**DESERT TORTOISE COUNCIL**

RE: Formal comments on the proposed Silurian Valley Solar Project

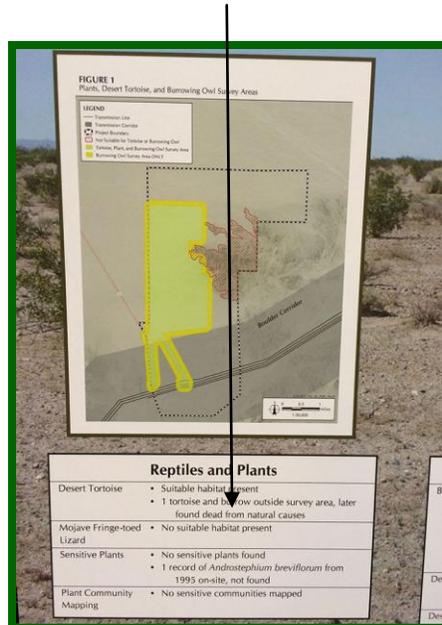
6. We note on Figure 1 (see below) that “1 tortoise and burrow [were found] outside survey area, later found dead from natural causes,” which was the only reported tortoise sign found during protocol surveys in 2013.

During the break when I spoke with Dr. Pauline Roberts of Sapphos, I was alarmed and felt misled when she indicated that, in fact, five tortoise burrows had actually been found **on the site**. There are several red flags associated with this revelation. First, if tortoise sign had been found onsite, why did Figure 1 divulge that only the one animal had been found in adjacent areas? It would certainly have been more appropriate and less misleading, to indicate on the figure that five burrows were found onsite, without necessarily revealing their exact locations, to protect tortoises.

Given that the biological report cannot be made public, we'd like to ask the BLM the following questions: Is this site considered occupied habitat, as the presence of five tortoise burrows would indicate? Or, are only adjacent areas occupied, as implied by Figure 1 that shows a single animal (now dead) was observed in adjacent areas only? Since the results of this 2013 survey remain valid for only one year per USFWS survey protocol and are therefore already outdated, the site must be surveyed again prior to development. As such, we strongly encourage the BLM to review the experience levels of future surveyors to ensure they have the ability to identify and differentiate tortoise sign from sign of other animals.

7. We also question the consultant's conclusion that the red-highlighted area in Figure 1 is not suitable for either tortoises or burrowing owls. Was this area deemed unsuitable as a result of surveys? Or, as it would appear, did the biologists not survey it because it appeared unsuitable? We note in Figure 1 that the red-highlighted area is outside the survey area for tortoises and burrowing owls, so how can the presence of these two species be dismissed in the absence of protocol surveys? In April 2014, I surveyed a similarly mountainous area south of Barstow that was occupied by both tortoises and burrowing owls (which were using tortoise burrows, kit fox dens, and badger digs in very rocky areas). Given its proximity to the proposed development and likelihood of supporting both tortoises and burrowing owls, the BLM (if this project is to proceed) must ensure that the red-highlighted area is actually surveyed to substantiate the consultant's apparently site-unseen conclusion.
